Sage Park
Department of Ecology
Central Region Office
Attn: Goldendale Energy DEIS
1250 W. Alder Street
Union Gap, WA 98903-0009

RE: Turlock Irrigation District's and Tuolumne Wind Project Authority's Comments on the Draft Environmental Impact Statement for the Goldendale Energy Storage Project.

However, Figure 5-10 in the 2021 WREA Study Report shows the proposed upper reservoir located in the middle of the TWPA wind farm with at least 15 turbines adjacent: 2 located on one

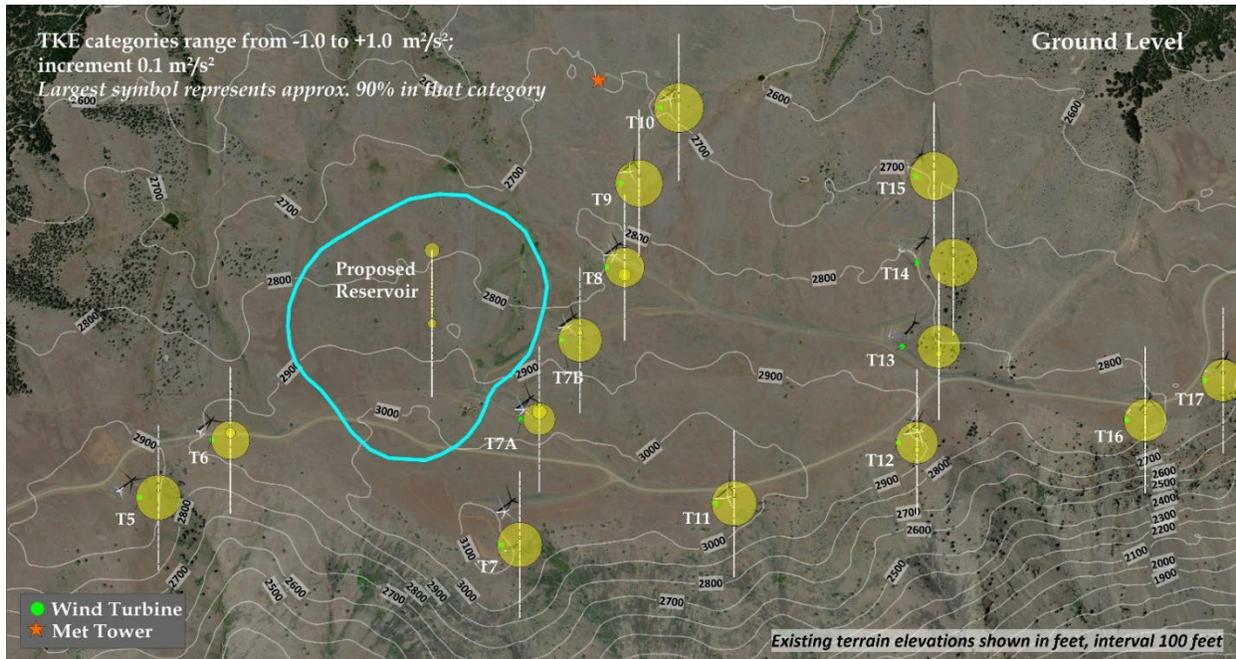
side of the reservoir and 13 located on the other. Several of the turbines are within a couple of meters of the location for the proposed upper reservoir.

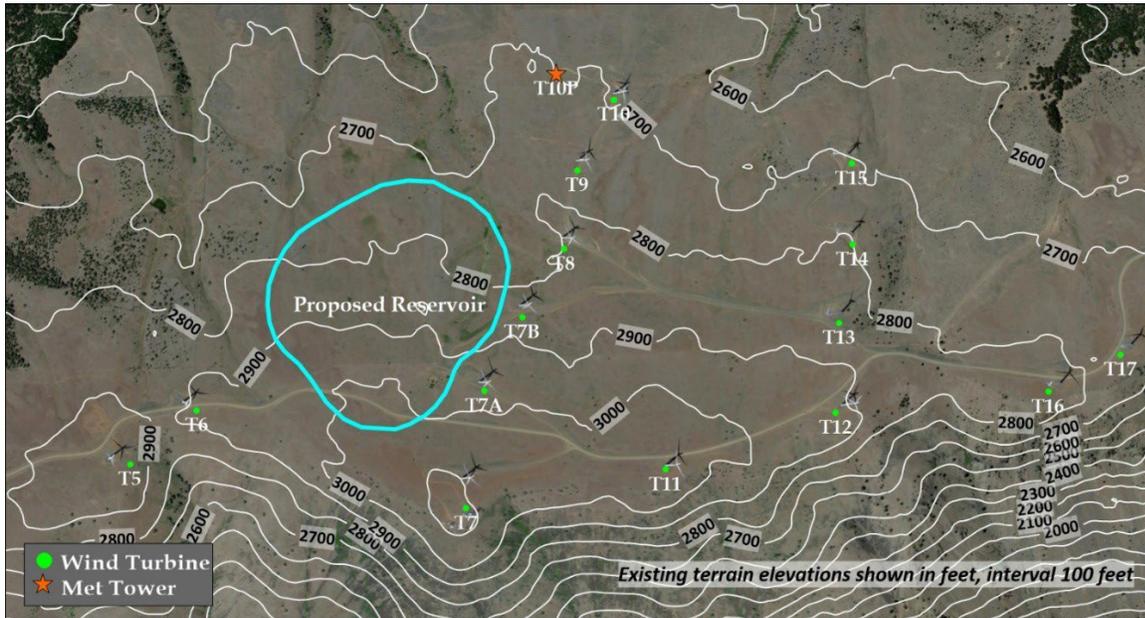
Figure ES-1 (above) shows that the Met Tower is a significant distance from all the turbines in the wind farm except one (T10) and is at an elevation that is 100 meters or more lower than all but two of the turbines (T10 and T15).¹³ More importantly, the data from this Met Tower is inapplicable to most of the turbines at the wind farm because the tower’s wind readings are taken from an elevation of between 40 and 80 meters above the tower’s 2700-meter elevation, which means that these wind readings are at most from a 2780-meter elevation. This elevation is well below the elevation of all but two of the turbines (T10 and T15). All other turbines are located at ground level elevations of 2800 to 3000 meters and their blade height is 120 meters above these ground elevations. Therefore, the Met Tower’s wind pattern readings used in the WRF model, and incorporated into 2021 WREA Study Report through the latter’s use of the WRF, are unsuitable to determine wind pattern changes for 13 of the 15 nearby turbines because they are taken from an elevation that is hundreds of meters below the wind patterns experienced by these 13 turbines.¹⁴ As such, the WRF model does not provide relevant, accurate data regarding wind patterns for the vast majority of the turbines at the wind farm. To be accurate and reflective of the wind patterns these turbines experience, the wind pattern readings should have been taken at much higher elevations.

The Met Tower’s wind pattern readings would not even be accurate for turbines T10 and T15 because they were only taken from elevations between 40 and 80 meters above their 2700-meter ground level elevation. However, to examine relevant wind patterns for turbines, data from at least a 120-meter height is needed because the turbines’ swept area¹⁵ extends to approximately 120 meters above the ground. Section 3 of the 2021 WREA Study Report states:

FFP admits that it relied on wind readings only from “vertical heights of 40-80 meters” above the ground level of the Met Tower, which Figure ES-1 shows to be 2700 meters. Therefore, the WRF

model relied on wind readings from only 2780 meters and below, even though 13 of the 15 turbines adjacent to the upper reservoir are located at ground elevations of 2800 meters or higher.
